Project	IEEE 802.16 Broadband Wireless Access Working Group < http://ieee802.org/16 >	
Title	Reuse / AAS enhancements for IEEE 802.16-REVd	
Date Submitted	2004-01-14	
Source(s)	Paul Petrus, Adam Kerr, Athos Kasapi, Todd Chauvin ArrayComm, Inc. 2480 N. First St., Suite 200 San Jose CA 95131	petrus@arraycomm.com adam@arraycomm.com athos@arraycomm.com john.dring@intel.com baraa.al.dabagh@intel.com
	John Dring Baraa Al Dabagh Intel Corporation 350 Plumeria Dr. San Jose, CA 95134	
Re:	Working Group re-circulation Ballot #13a Announcement	
Abstract	Reuse / Enhancements for AAS support, to enable operation in high interference environments	
Purpose	Adoption of proposed enhancement into P802.16-REVd/D3-2003	
Notice	This document has been prepared to assist IEEE 802.16. It is offered as a basis for discussion and is not binding on the contributing individual(s) or organization(s). The material in this document is subject to change in form and content after further study. The contributor(s) reserve(s) the right to add, amend or withdraw material contained herein.

Reuse/AAS Enhancements for IEEE 802.16d

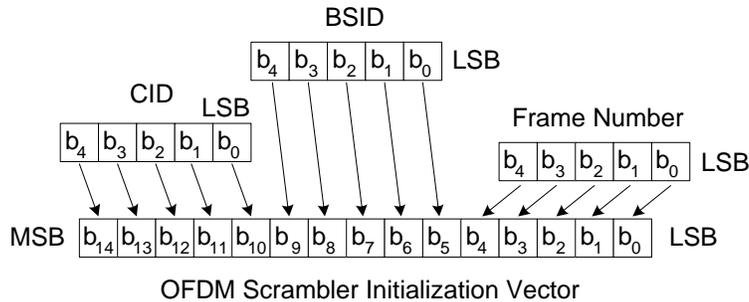
In order to create a randomization that is dependent on both base station and the user (or connection), we introduce modifications to this seed value. For the preambles and broadcast portion of the downlink frame (FCH and burst #1) we recommend maintaining the fixed constant seed value as currently defined. For all other downlink bursts and all uplink bursts, we recommend that a combination of base station ID, connection ID, and frame number determine the seed value for the shift register, rather than the current combination of DIUC/UIUC and symbol number.

The base station ID is a 48-bit value, the basic ID (CID) is 16 bits, and the frame number is 24 bits; these can be combined together with a simple hashing function to produce the seed for both uplink and downlink transmissions. The basic CID is included since at sector boundaries, different SUs communicating with different sectors of the same basestation may interfere, and the frame number is included in order to ensure that retransmissions are differently scrambled and are not distorted with the same peak-power nonlinearities.

3. Figure 192 is replaced with:

1. The paragraph immediately above Figure 192 is changed to read:
“ On the downlink, the randomizer shall be re-initialized at the start of each frame with the vector: 1 0 0 1 0 1 0 1 0 0 0 0 0 0 0. The randomizer shall not be reset until the burst immediately following the completion of the DL-MAP. The vector shown in Figure 192 shall be used to initialize the randomizer at the start of that and subsequent bursts. The frame number and BSID are consistent with the PHY synchronization field of the DL-MAP of the frame, while the basic CID is consistent with the DL-MAP IE parameterizing the burst.”

2. The paragraph immediately above Figure 193 is changed to read:
“ On the uplink, the randomizer is initialized with the vector shown in Figure 192. The frame number and BSID are consistent with the PHY synchronization field of the DL-MAP of the frame, while the basic CID is consistent with the UL-MAP IE parameterizing the burst.”

Slotted Broadcast Resources

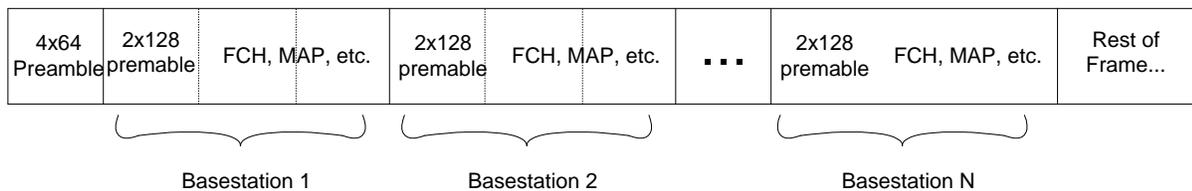
The basic idea here is for each BS to transmit the 4x64 preamble simultaneously with the other basestations, but to transmit the 2x128 preamble, FCH, and MAP bursts in its own allocated ‘slot’.

By ensuring that there is enough guard time between these ‘slots’, and allocating them consistently across a network, an operator can control interference in the broadcast channels of the network.

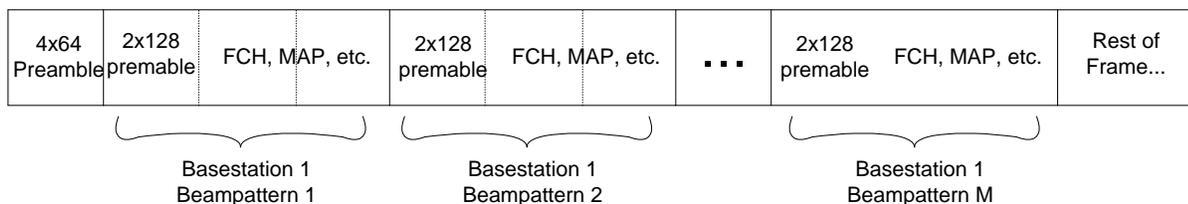
The second symbol of the long preamble transmitted by nearby basestations, and the broadcast MAC messages, need to be as ‘orthogonal’ as possible. The most direct way to do this is to allocate a different set of subcarriers to each basestation for these transmissions. For instance, a re-use of 4 can be created by forming one preamble symbol from only the subcarriers of section 8.3.3.6 numbered $k=0 \pmod{4}$, a second preamble from the subcarriers numbered $k=1 \pmod{4}$, etc... to create four distinct, orthogonal preambles. The same subcarrier allocation can be used for the other broadcast messages of a given basestation’s frame.

The penalty for creating re-use in this manner is that the broadcast messages would use four times the resources that they presently do. The benefit is greatly reduced interference, and this may in fact be required to create a viable wide-area network. In fact, a yet more aggressive re-use than 4 may be required for wide-area

deployment. A further benefit is that these symbols may be transmit with higher power than symbols using all subcarriers; this gives a significant boost to the link budget for broadcast bursts in AAS systems.
